Road Department

ADDENDUM NO. 1

CONSTRUCTION OF THE POWELL BUTTE HIGHWAY ROUNDABOUT

ILLUMINATION PLAN

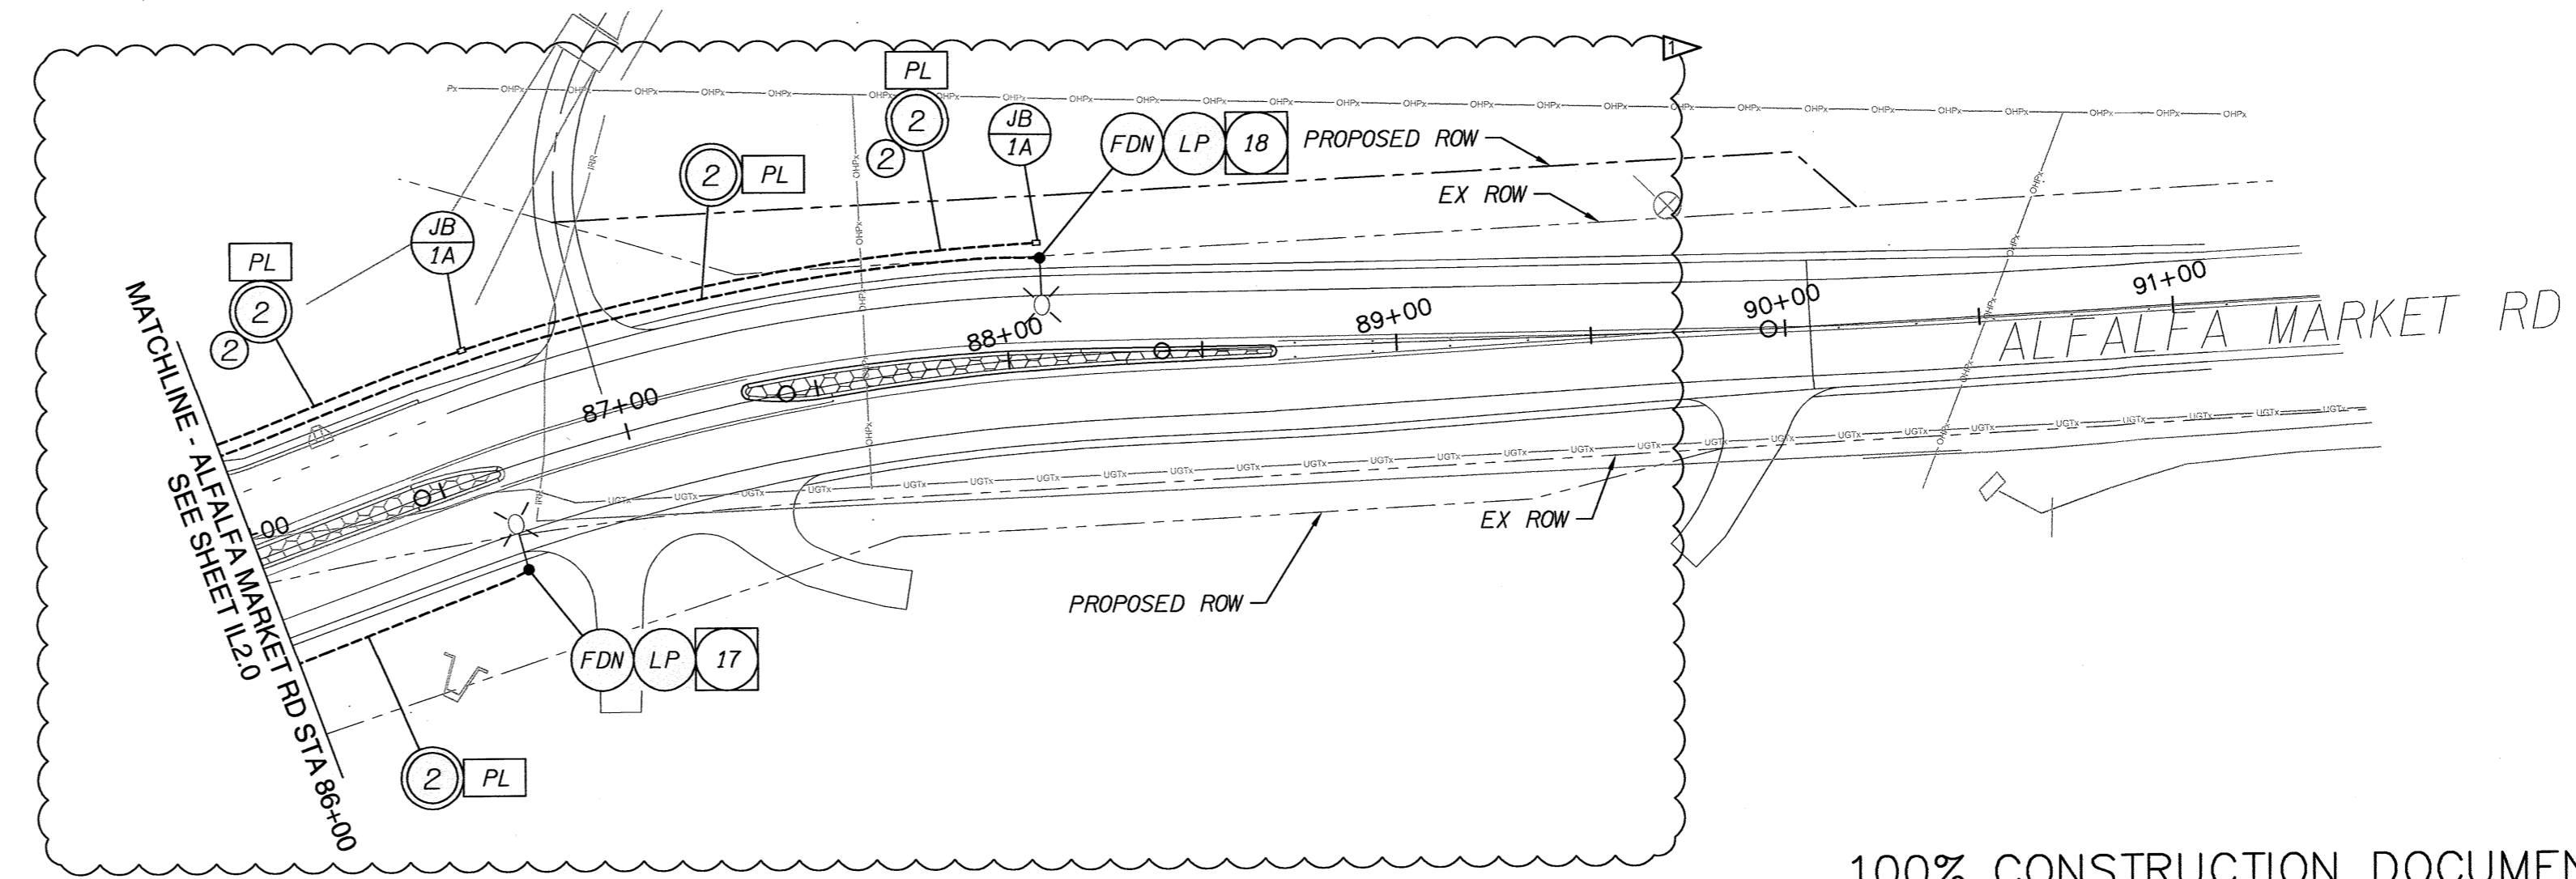
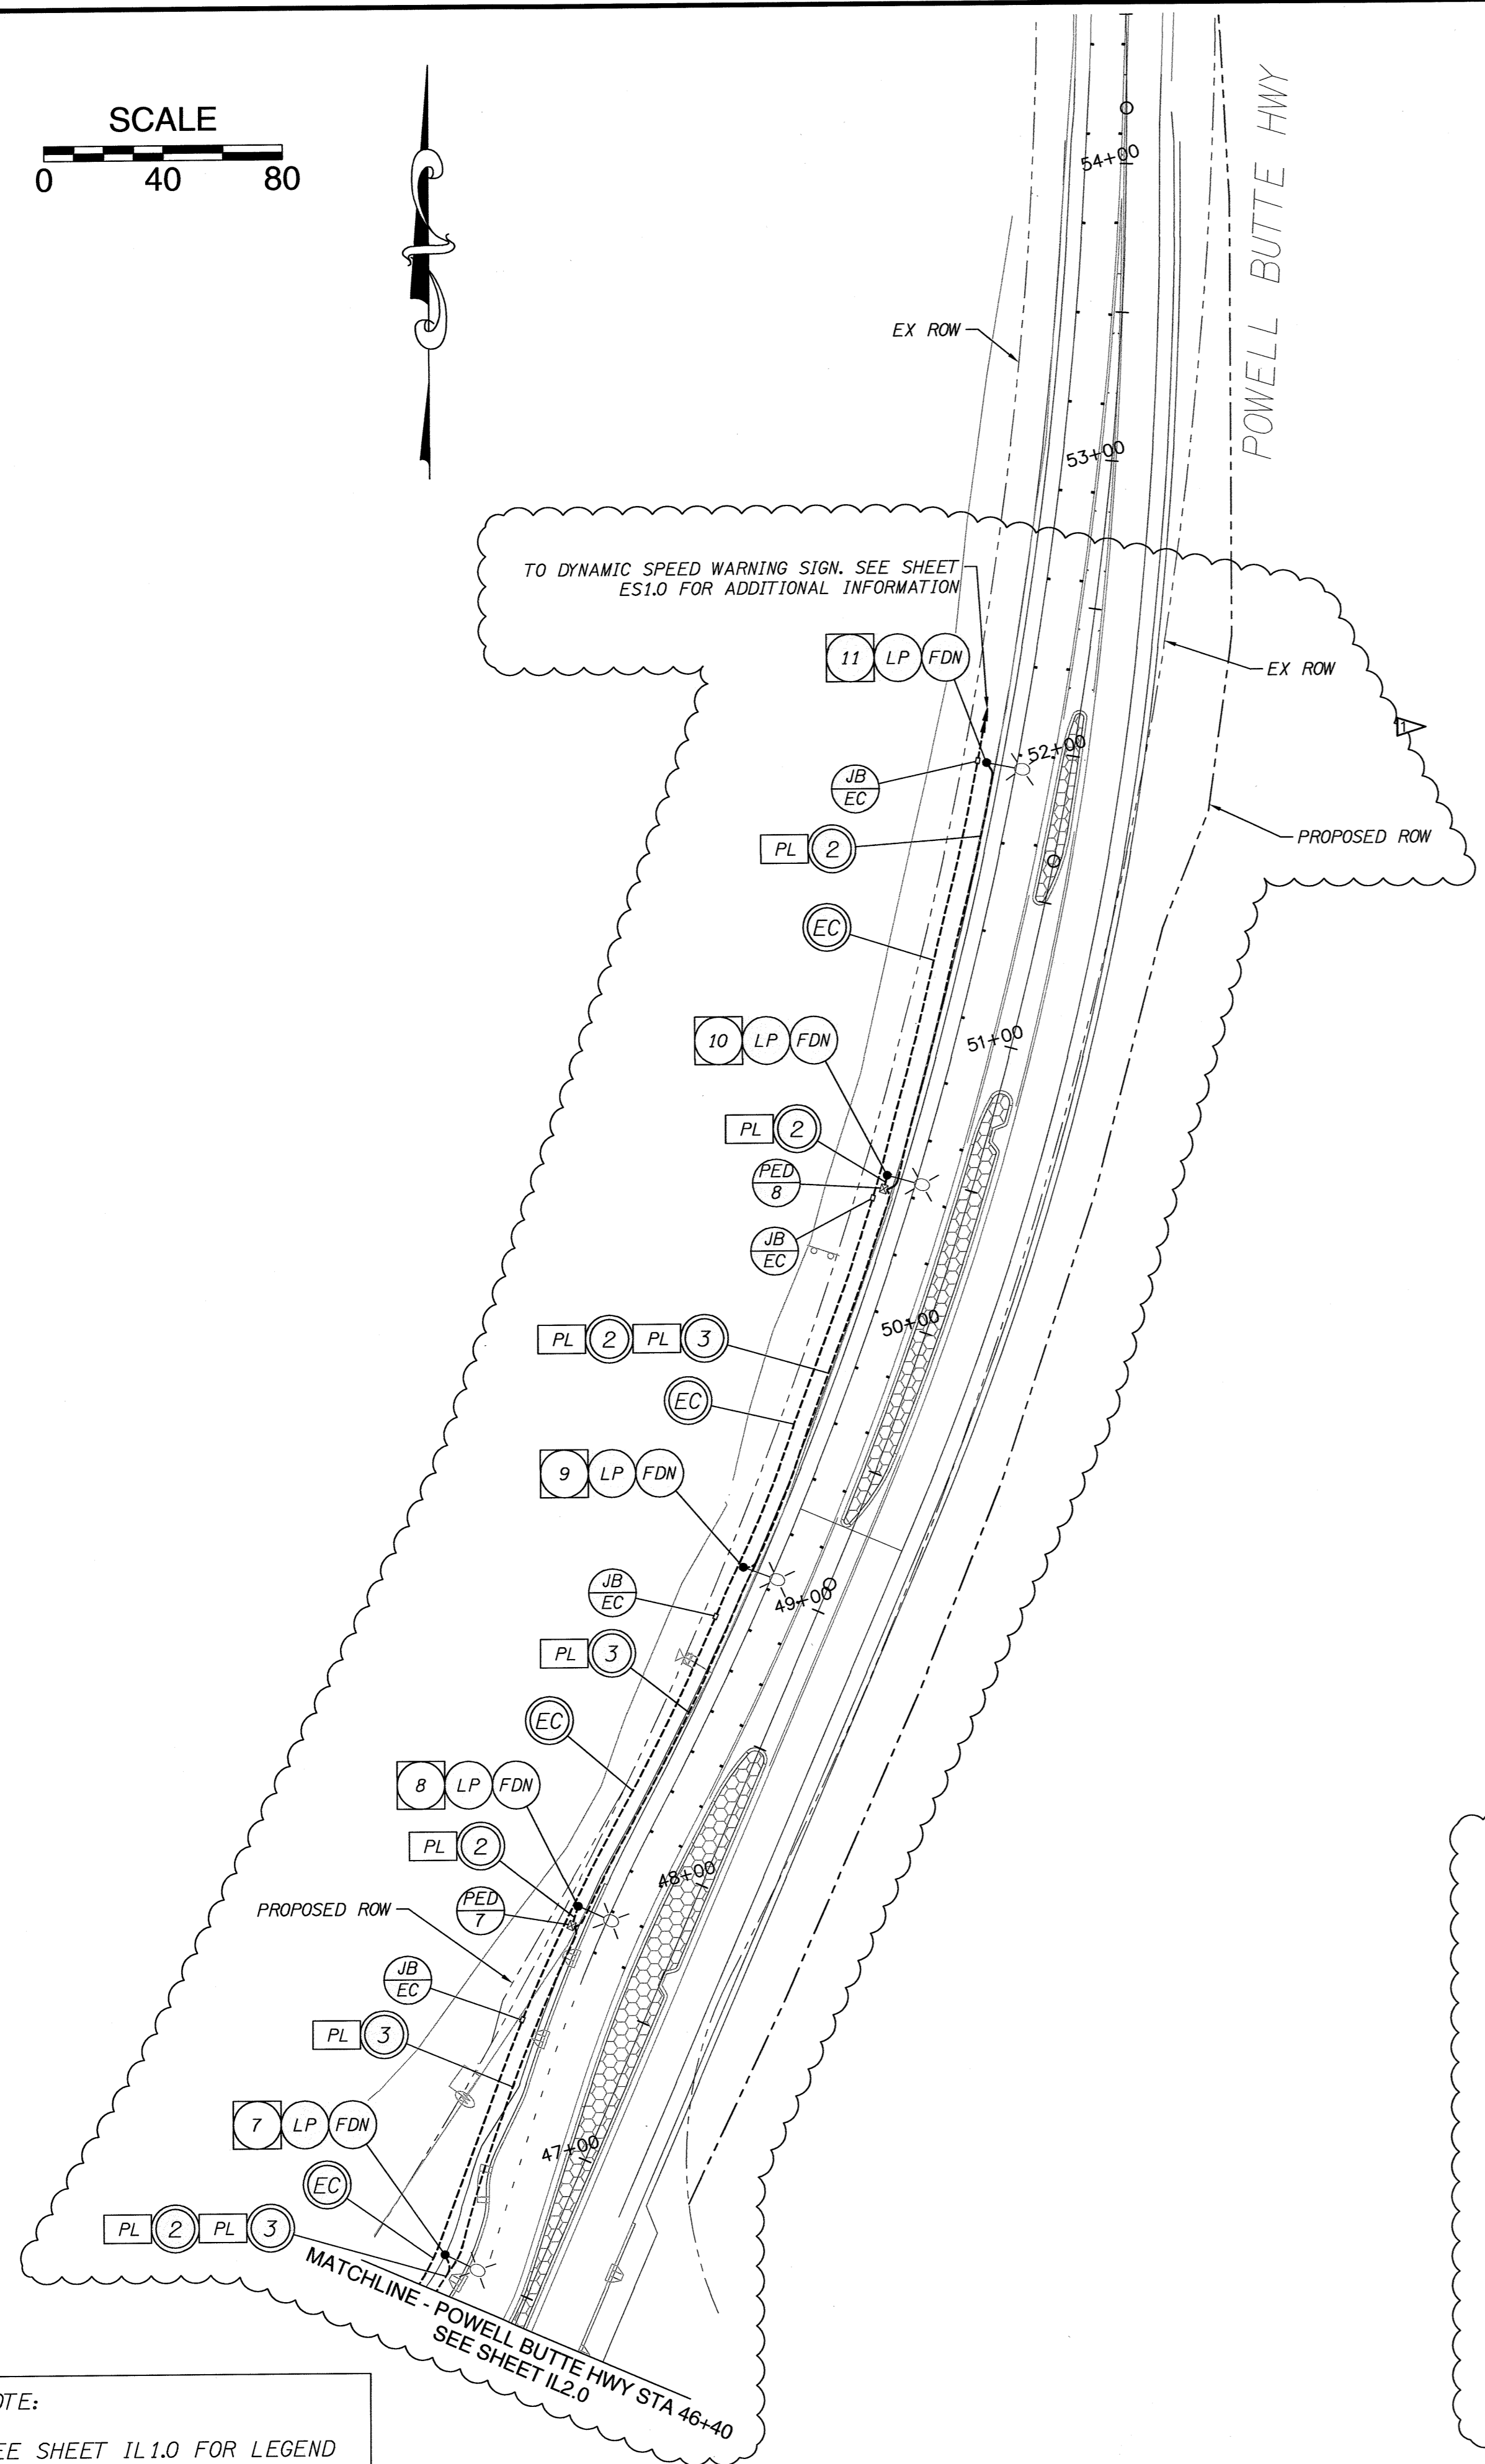
- a. Plan has been updated to reflect changes to conduit layout requested by Central Electric Cooperative. All service cabinets identified on the IL sheets have been removed and replaced with pedestals to be installed by Central Electric Cooperative. All conduit for potential future dynamic warning signs will be installed through junction boxes. All conduit for the street lighting system will be laid and stubbed at locations shown for pedestal installation by Central Electrical Cooperative. Where possible, the same trench should be used for conduit associated with both systems.
